1958 Agreement - Regulations**Regulations Nos. 37 (Filament lamps) and 128 (Light emitting diodes light sources)****Proposal for Supplement 4 to the original series of amendments to Regulation No. 128 (Light emitting diode (LED) light sources)****Submitted by the expert from the International Automotive Lighting and Light Signalling Expert Group (GTB)***

The text reproduced below was prepared by the expert from the GTB to introduce new categories LR3A, LR3B, LR4A, LR4B and correct one value in the ultraviolet (UV) table. The modifications to the existing text of the Regulation are marked in bold for new or strikethrough for deleted characters.

Figure 1*
 Main Drawing, LR3A (top) and LR3B (bottom)

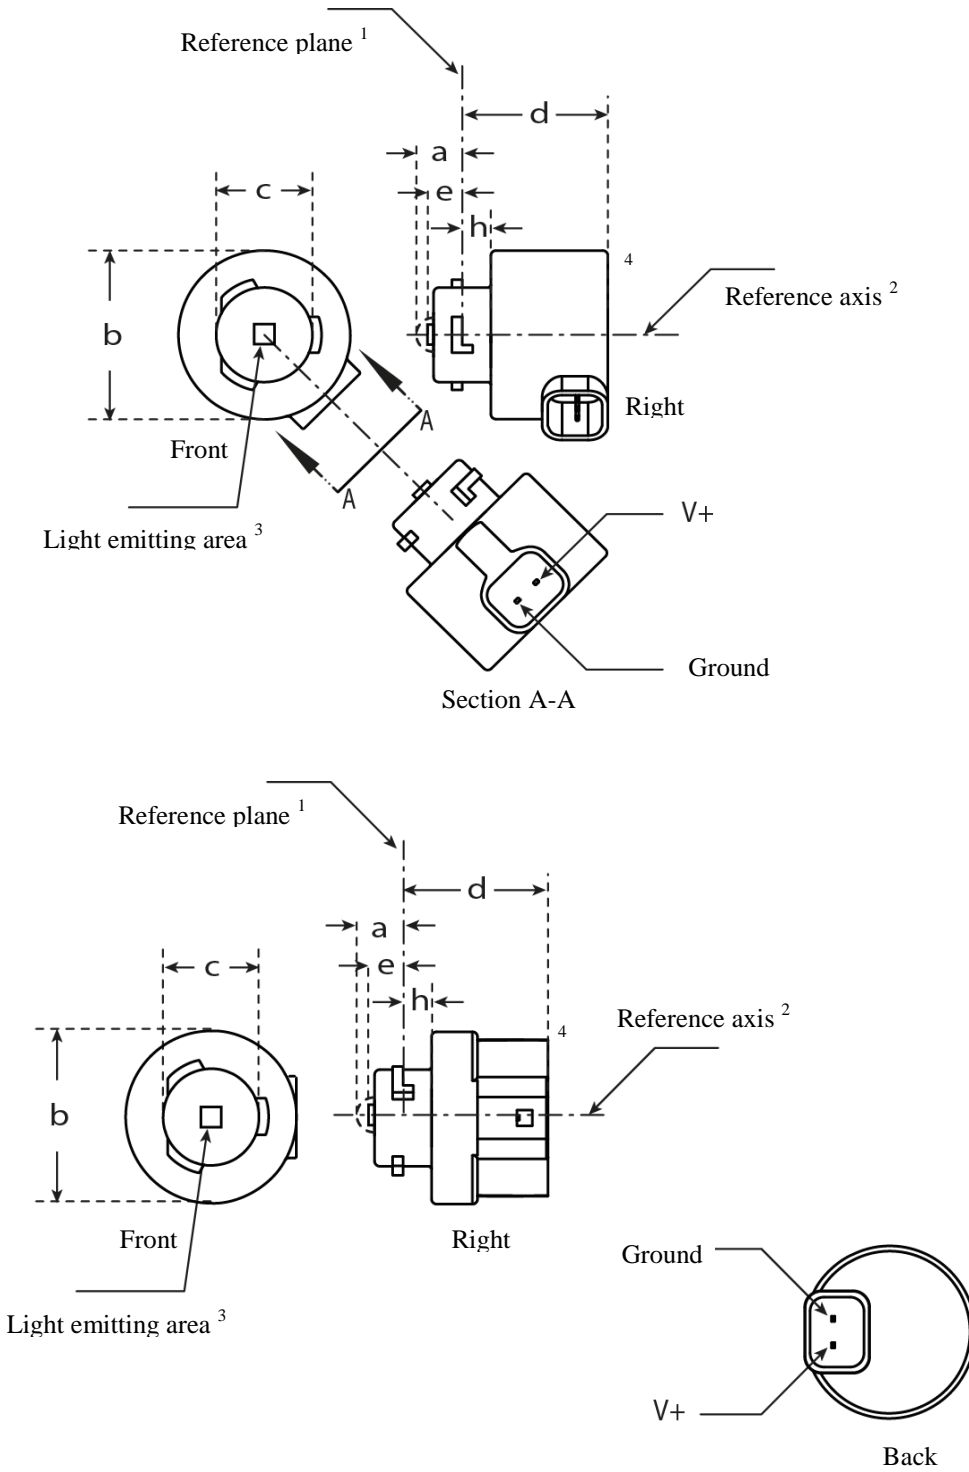
Insert new sheets LR3/1 to 5 and LR4/1 to 5, after sheet LW2/5, to read:
See following pages; one page per sheet.

Dimensions		Production LED light sources	Standard LED light sources
a	mm	6.0 max.	
b	mm	c + 10.0 min. 38.0 max.	
c	mm	18.5 ± 0.1	
d	mm	28.0 max.	
e	mm	3.0 ± 0.30	3.0 ± 0.15
h	mm	5.5 + 0.0/ - 0.1	
Cap PGJ18t-[xx] in accordance with IEC Publication 60061 (sheet 7004-[xxx]-1)			
Electrical and photometric characteristics ⁵			
Rated values	Volts	12	
	Watts	3	
Objective Values ⁶	Watts (at 13.5 V DC)	3.5 max.	3.5 max.
	Luminous flux (in lm at 13.5 V DC)	80 ± 20% ⁷	80 ± 10% ⁸
	Luminous flux (in lm at 9 V DC)	19 min.

Figure 2

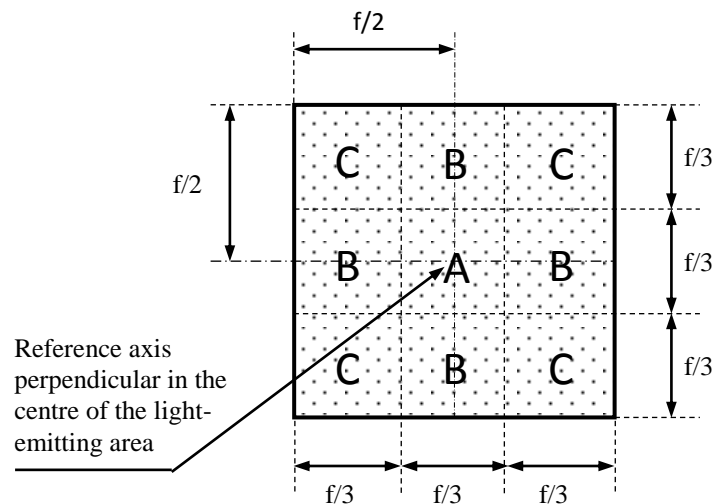
The position of the light emitting area is checked by the box system defined in Figure 2, which is aligned to the planes C90 and C180 and shows the projection when viewing along direction $\gamma=0^\circ$ (C, γ as defined in Figure 3).

Dimensions in mm	f
LED light sources of normal production	3.0
Standard LED light sources	3.0

Area(s)	LED light sources of normal production	Standard LED light sources
A	$\leq 25\%$	$\leq 10\%$
Each B individually	$\geq 15\%$	$\geq 20\%$
Each C individually	-	$\leq 10\%$
A, all B and all C together	$\geq 90\%$	$\geq 90\%$

Figure 3
Set-up to measure the luminous intensity distribution, LR3A (top) and LR3B (bottom)

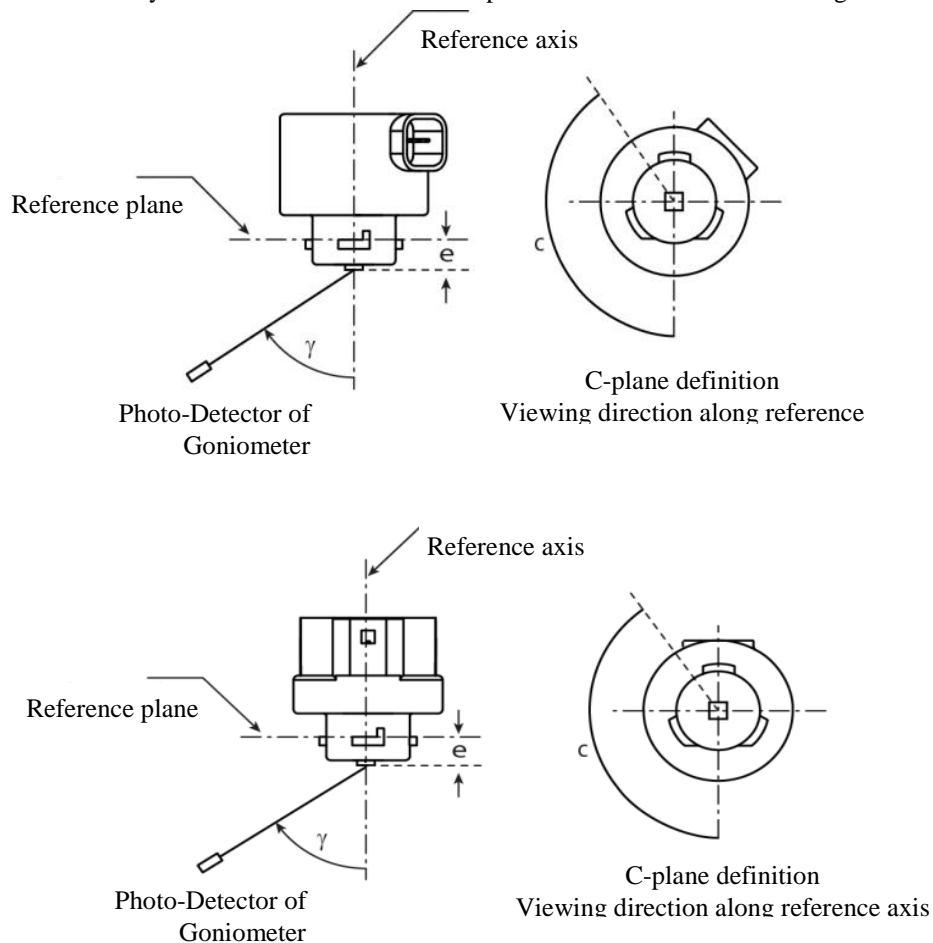
The light source is mounted on a flat plate with the corresponding mounting lug features. The plate is mounted to the goniometer table by a bracket, so that the reference axis of the light source lines up with one of the rotating axis of the goniometer. The corresponding measurement set-up is described in Figure 3.

Angle γ	<i>LED lamps of normal production</i>		<i>Standard LED lamps</i>	
	<i>Minimum Intensity in cd /1000 lm</i>	<i>Maximum Intensity in cd/1000 lm</i>	<i>Minimum Intensity in cd /1000 lm</i>	<i>Maximum Intensity in cd /1000 lm</i>
-90°	0	38	0	25
-75°	0	160	0	140
-60°	98	246	127	220
-45°	142	305	181	275
-30°	169	352	213	315
-15°	192	389	239	340
0°	200	401	248	352
15°	192	389	239	340
30°	169	352	213	315
45°	142	305	181	275
60°	98	246	127	220
75°	0	160	0	140
90°	0	38	0	25

Figure 2

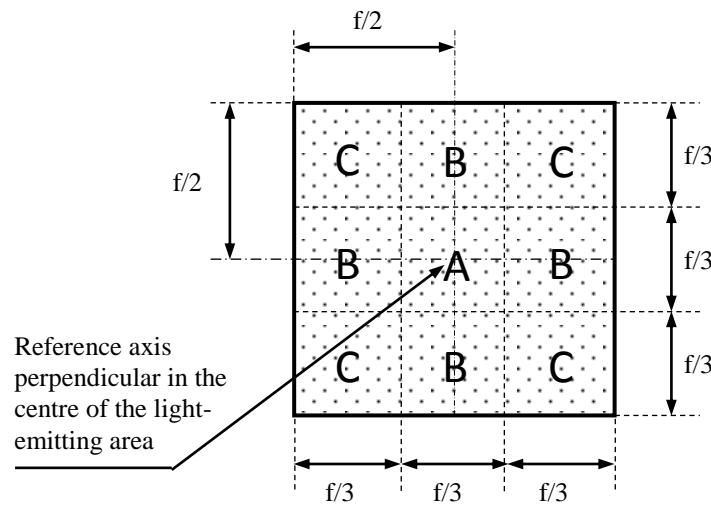
The position of the light emitting area is checked by the box system defined in Figure 2, which is aligned to the planes C90 and C180 and shows the projection when viewing along direction $\gamma=0^\circ$ (C, γ as defined in Figure 3).

Dimensions in mm	f
LED light sources of normal production	4.5
Standard LED light sources	4.5

Function	Area(s)	LED light sources of normal production	Standard LED light sources
Minor	A	$\geq 75\%$	$\geq 80\%$
Major	A	$\leq 25\%$	$\leq 10\%$
	Each B individually	$\geq 15\%$	$\geq 20\%$
	Each C individually	-	$\leq 10\%$
	A, all B and all C together	$\geq 90\%$	$\geq 90\%$

Set-up to measure the luminous intensity distribution, LR4A (top) and LR4B (bottom)

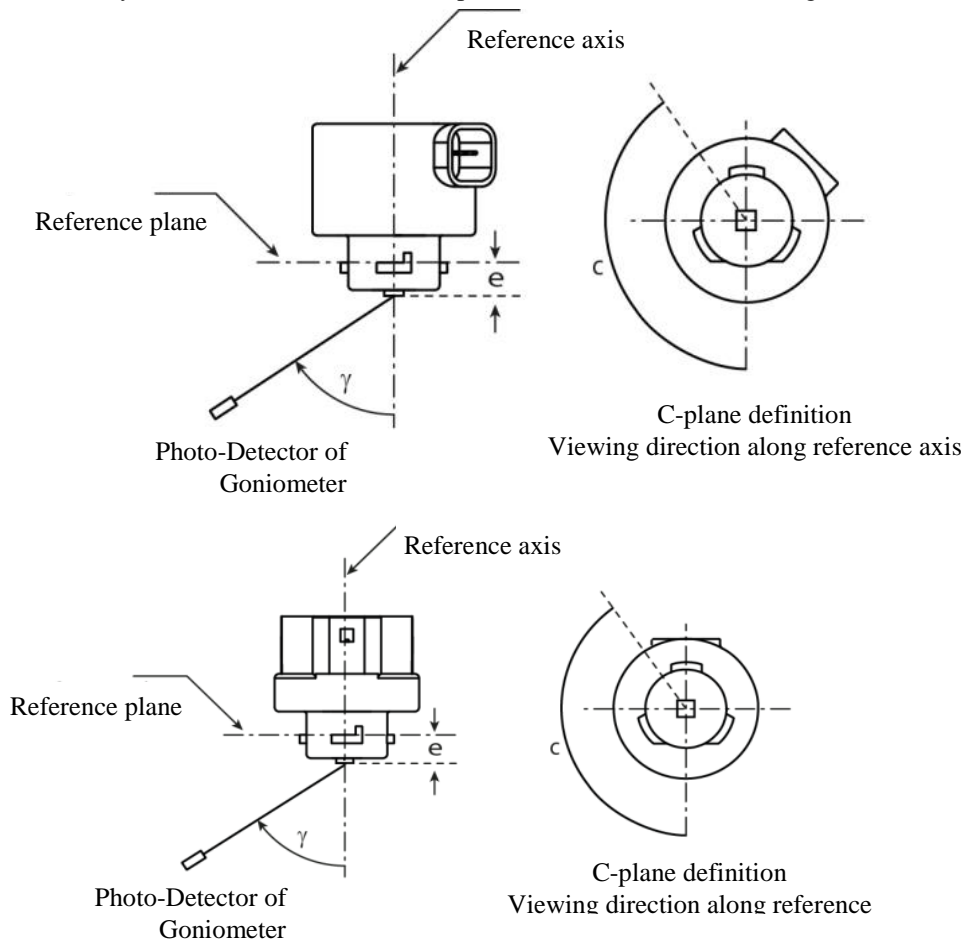
The light source is mounted on a flat plate with the corresponding mounting lug features. The plate is mounted to the goniometer table by a bracket, so that the reference axis of the light source lines up with one of the rotating axis of the goniometer. The corresponding measurement set-up is described in Figure 3.

Angle γ	LED lamps of normal production		Standard LED lamps	
	Minimum Intensity in cd /1000lm	Maximum Intensity in cd/1000lm	Minimum Intensity in cd /1000lm	Maximum Intensity in cd/1000lm
-90°	0	38	0	25
-75°	0	160	0	140
-60°	98	246	127	220
-45°	142	305	181	275
-30°	169	352	213	315
-15°	192	389	239	340
0°	200	401	248	352
15°	192	389	239	340
30°	169	352	213	315
45°	142	305	181	275
60°	98	246	127	220
75°	0	160	0	140
90°	0	38	0	25
